**PLANNING BOARD ZOOM FEBRUARY 23, 2021 4PM AGENDA
CONDUCTED WITH ZOOM
FEBRUARY 23, 2021 4:00 PM – TUESDAY**

**BOROUGH OF MANASQUAN
ORDINANCE NO. 2334-21**

**ORDINANCE AMENDING CHAPTER 33 (SITE PLAN REGULATIONS)
SECTION 33-7 (APPLICABLE ZONES)**

1727/20 - REVERSED PER OWNER & PLANNING BOARD ENGINEER REVIEW COMMENTS
VASILENKO PRELIMINARY & FINAL SITE PLAN
 43 TAYLOR AVENUE
R.C. ASSOCIATES
Consulting, Inc.
 Valley Park Professional Center
 2517 Route 305 Building J Suite 102
 Manasquan, New Jersey, 08736
 Ph. 732-528-0141 • Fax 732-528-1060

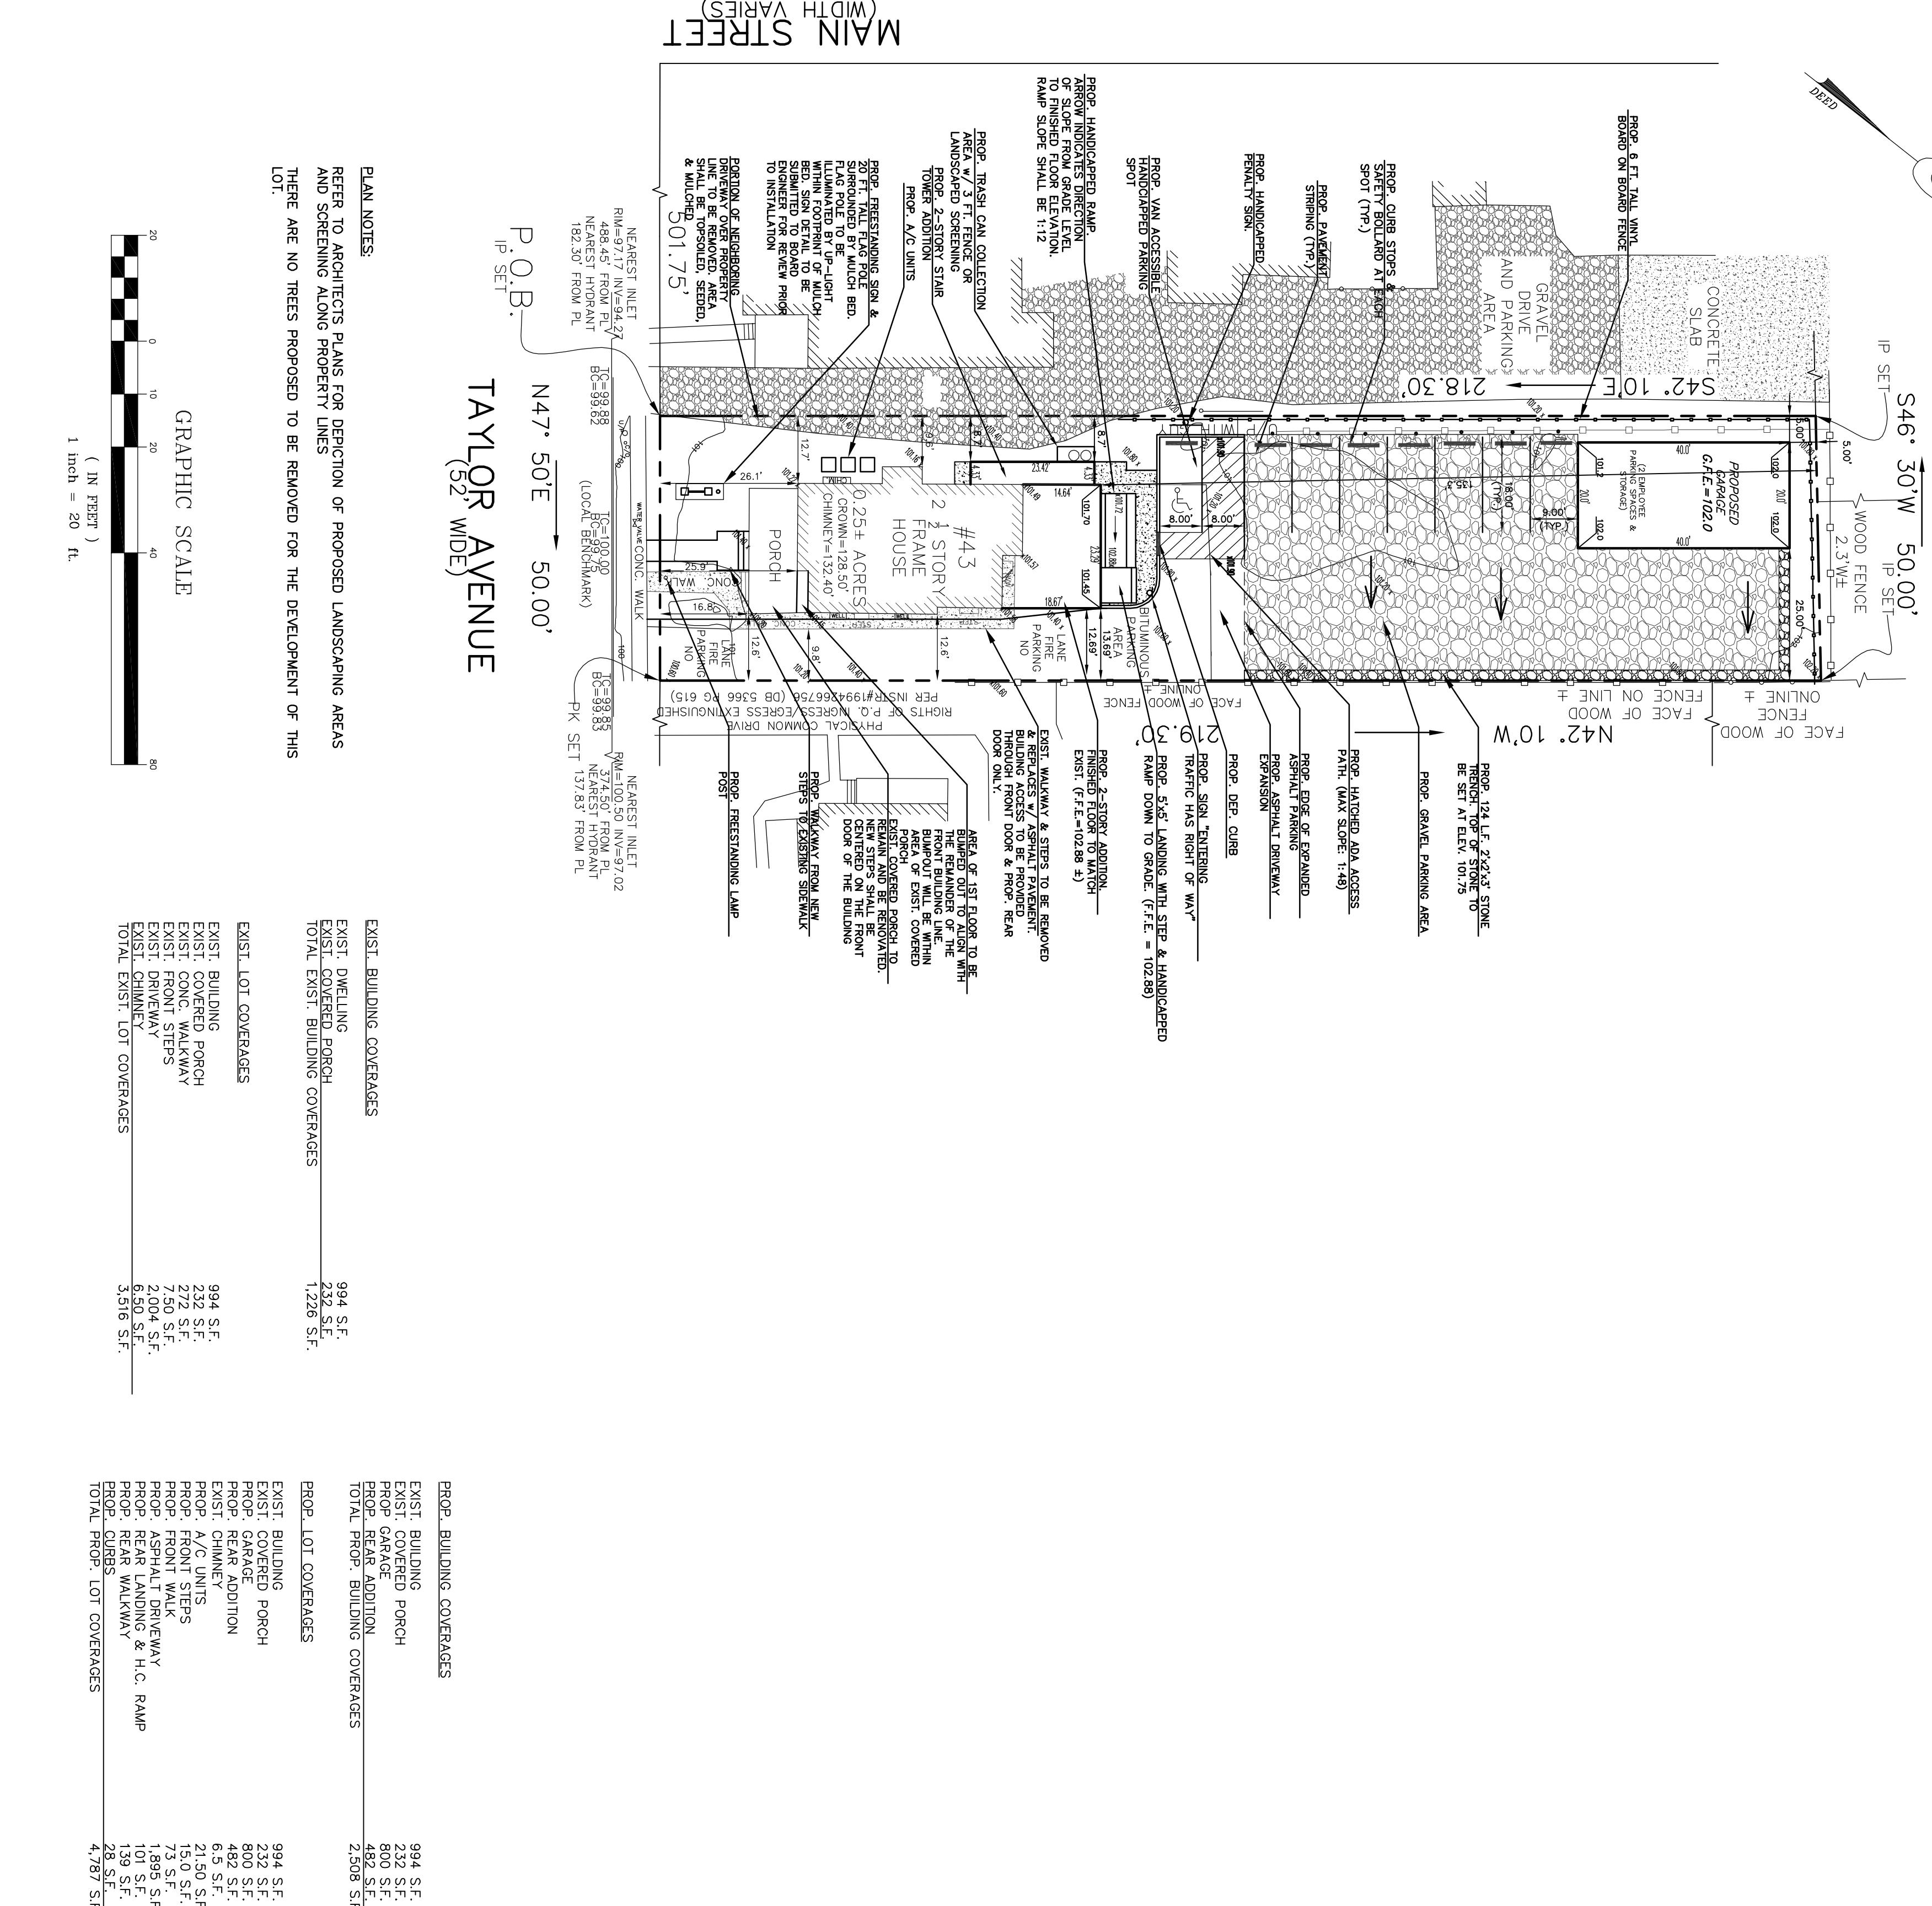
PROPERTY SHALL BE SERVICED BY EXISTING PUBLIC SEWER AND WATER SERVICES
 - EXISTING CURB SHALL BE REPLACED AS DETERMINED BY THE ZONING OFFICER OR BOROUGH ENGINEER
 - BOUNDARY & TOPOGRAPHIC INFORMATION TAKEN FROM A SURVEY ENTITLED 'EXISTING CONDITIONS MAP FOR APPLICATION OF VARIANCE (INCLUDING EXISTING GRADING)', PREPARED FOR DAVID & GAIL VASILENKO BY ENGINEER DANIEL M. DAVIS AND DANIEL M. DAVIS, ENGINEERS, L.L.C., DATED 11-5-19, 246590433700, ON BEHALF OF DANIEL M. DAVIS AND DANIEL M. DAVIS ENGINEERS, L.L.C., DATED 11-5-19.
